FILE P. I. No. 0007217, Walton/Newton Counties **OFFICE** Preconstruction
CSSTP-0007-00(217)
Social Circle Bypass
DATE October 26, 2007

SUBJECT APPROVED PROJECT CONCEPT REPORT

SUBJECT: PROJECT CONCEPT REPORT

SUBJECT: PROJECT CONCEPT REPORT
CSSTP-0007-00(217) / Walton & Newton Counties
Social Circle Bypass / SR 11 to E. Hightower Trail

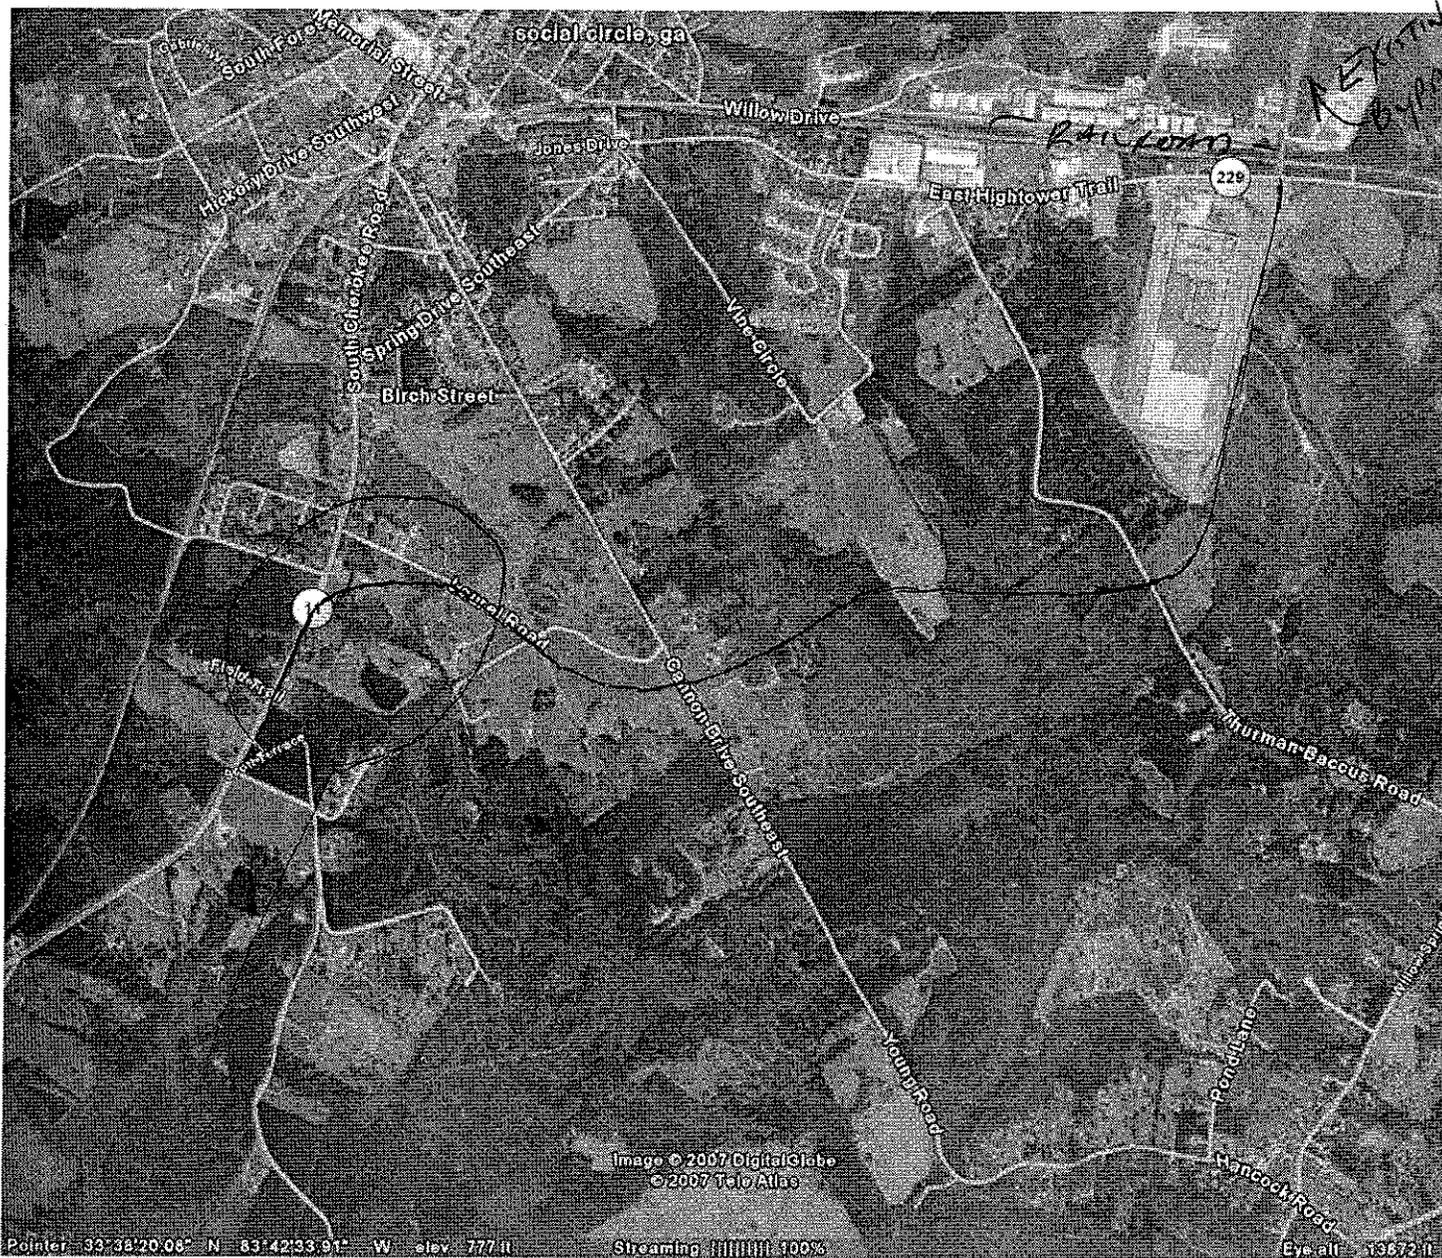
- ① HAZARD INDEX 2.45
 - ② DESIGN EXCEPTION REQUIRED FOR HORIZONTAL CURVE AT BEGINNING OF PROJECT.
 (with a note: *Can't do it either way to avoid exception for a road on "new location" displacements*)
- JPEL

STATE OF GEORGIA DEPARTMENT OF TRANSPORTATION OFFICE: CONSULTANT DESIGN		REVISION DATES	NOT TO SCALE	RS&H 730 PEACHTREE STREET, SUITE 430 ATLANTA, GA 30308 PHONE: 404-527-7200 FAX: 404-347-8922	SOCIAL CIRCLE BYPASS NEWTON AND WALTON COUNTIES	DRAWING NO. 5-01
TYPICAL SECTION

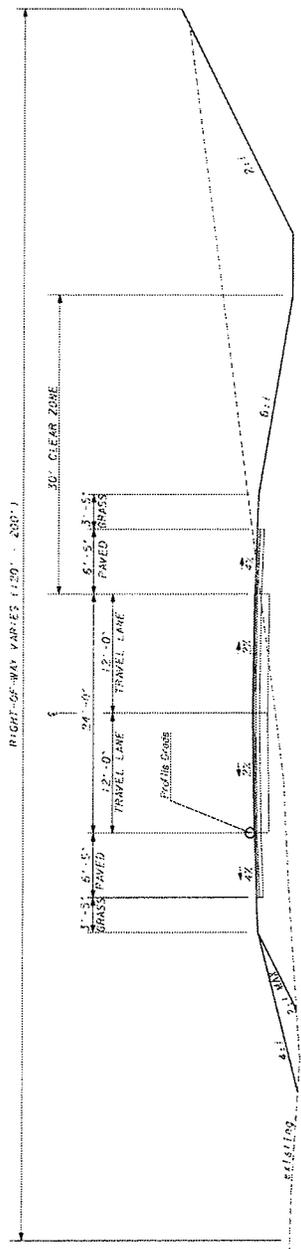
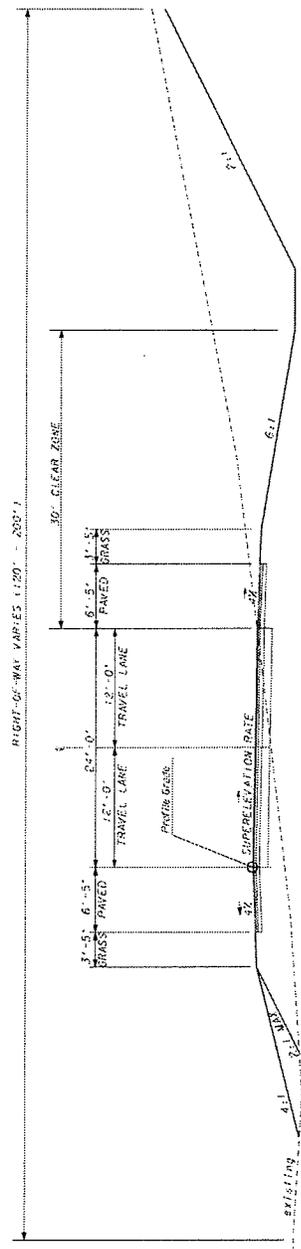
3. *Provide Melanie Nable, GDOT OEL, with a copy of the environmental schedule.*
4. *Revise the typical section to use 6.5' paved shoulders Instead of 8' paved shoulders.*
